From: [Detterman, Karel, Env. Health](#)
To: [john buestad](#)
Cc: [Jamie Keating](#); [Ken Carvalho](#); ["Jeremy Smith"](#); [Peter McIntyre](#); [Tom Graf](#); [Roe, Dilan, Env. Health](#)
Subject: Re: Fuel Leak Case RO3112 - Global ID T10000004754 Good Chevrolet Parcel A, 1600 Park St., Alameda, CA
Date: Friday, February 07, 2014 3:30:59 PM
Attachments: [RO3112 Figure 6 boring relocation request.pdf](#)

Thank you for submitting the *Source Removal Excavation Report and Work Plan for Additional Characterization* (Work Plan) dated January 15, 2014, submitted on your behalf by AEI Consultants (AEI). Alameda County Environmental Health (ACEH) has reviewed the case file and the Work Plan, which proposes drilling three direct-push borings along Park Street adjacent to the former location of two underground storage tanks (USTs) discovered and removed in October 2013. The purpose of the three direct push borings (AEI-29, AEI-30, and AEI-31) is to delineate residual soil and groundwater impact in the assumed downgradient direction from the two former USTs. A contingency is included for the installation of two additional step-out borings (AEI-32 and AEI-33) on the northwest side of Park

FIGURE 6
PROJECT NO. 324771

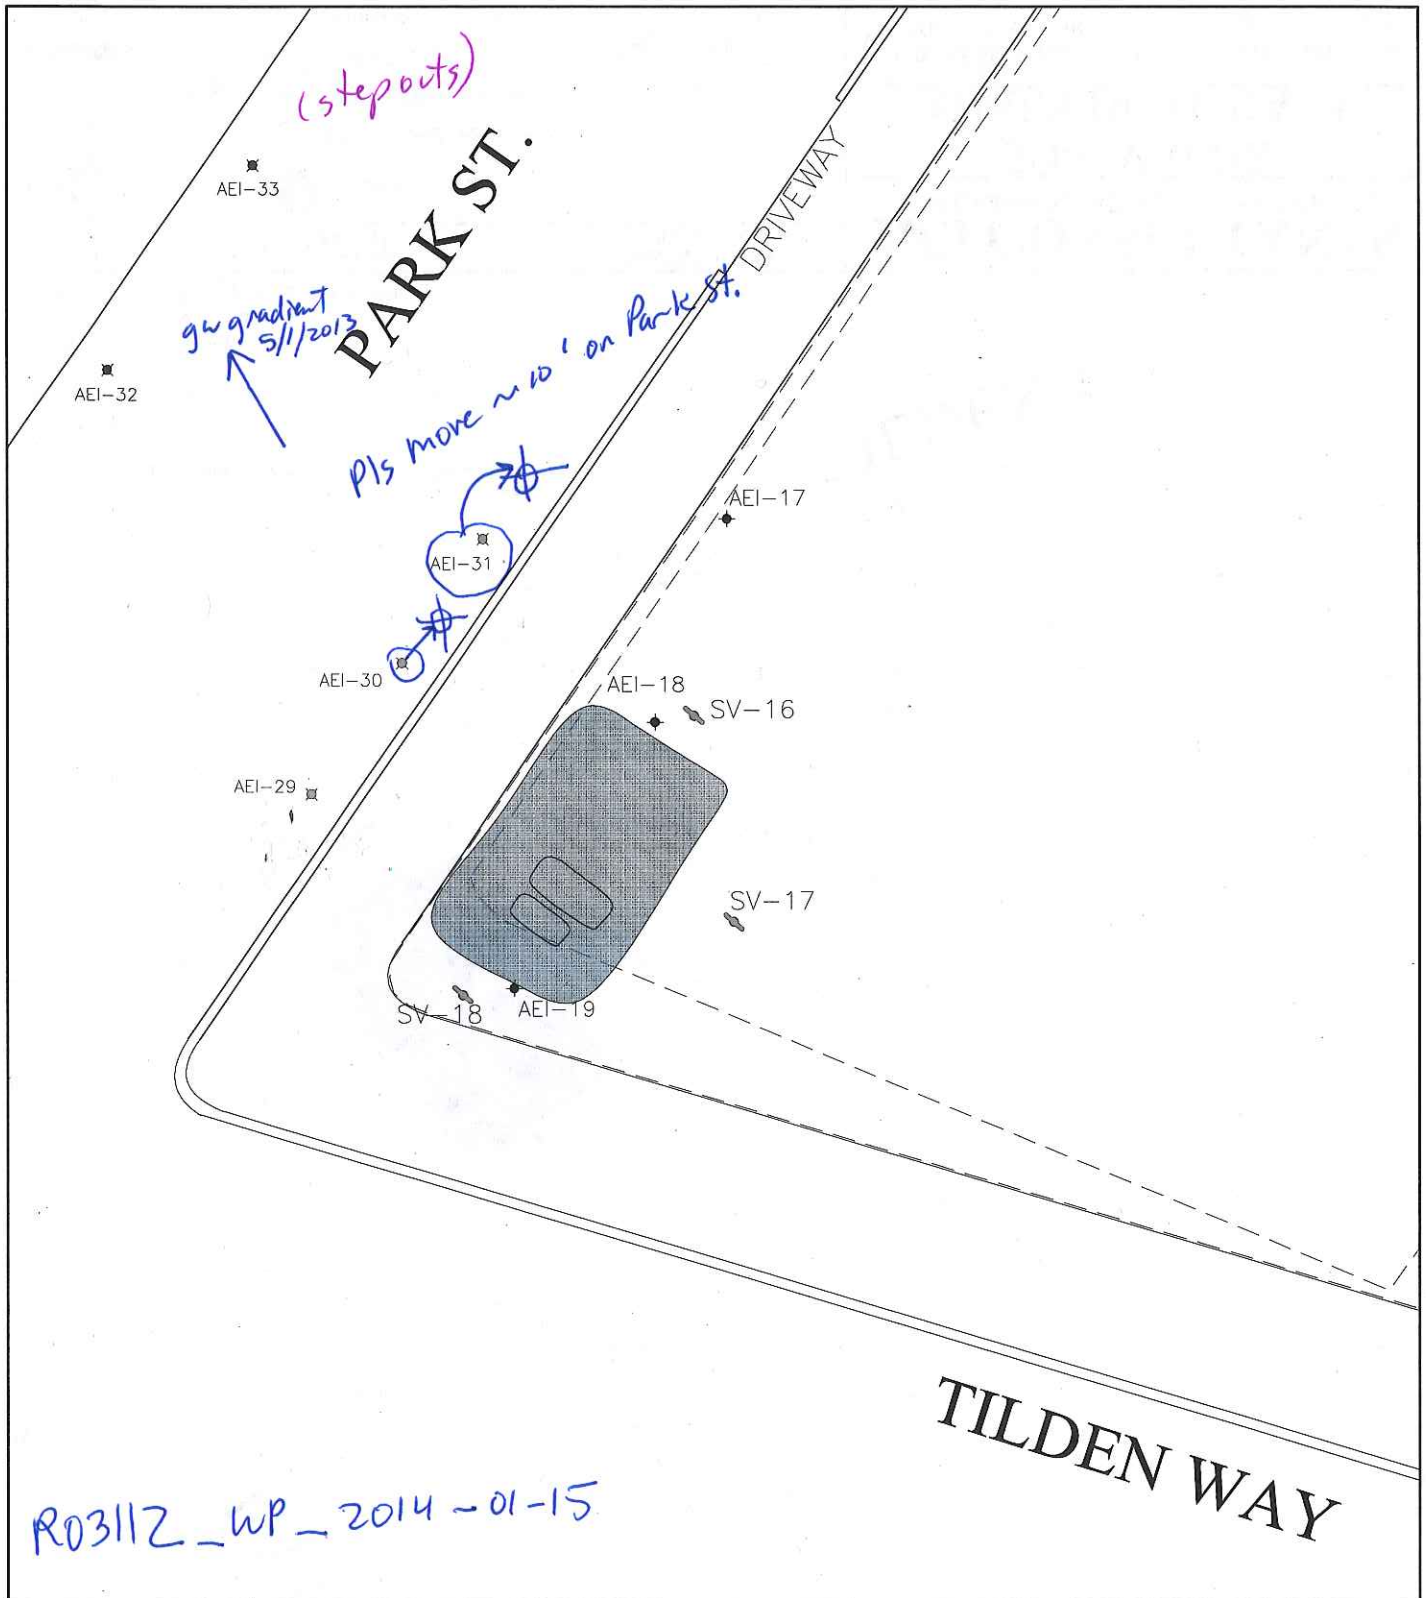
1. Work Plan Modification – The referenced work plan proposes a series of actions with which ACEH is in general agreement; however, ACEH requests one modification to the approach. As shown in the attached Figure 6, Proposed Soil Borings, from the Work Plan, please move each proposed soil boring AEI-30 and AEI-31 approximately 10 feet to the northeast along Park Street to provide broader coverage in the assumed downgradient direction along Park Street.
